To: Dan Fisk, Paramounte Engineering
From: Brian Chambers, Senior Planner; 910.342.2782
CC: File;
Date: 11/4/2020
Re: The Pointe at Barclay Phase 3 Hotel TRC Rev. 2

Project Name: **BARCLAY WEST - THE POINTE AT BARCLAY PHASE 3 HOTEL**

Formal TRC #2 Date: **10.30.2020**

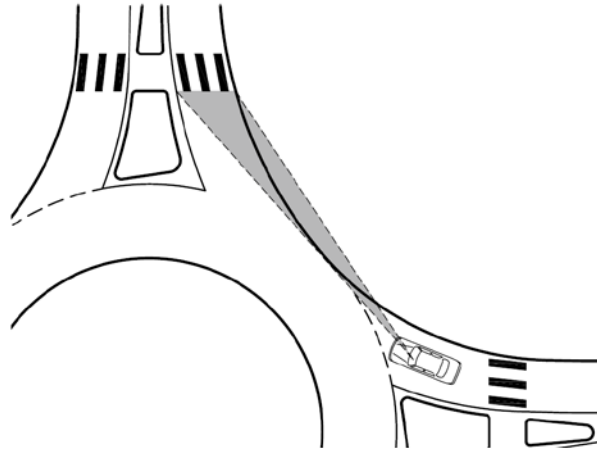
1. Show a stopping sight distance to crosswalk on exit on Stone Crop Dr, north of a roundabout on site/landscape plans. Below image is for reference.
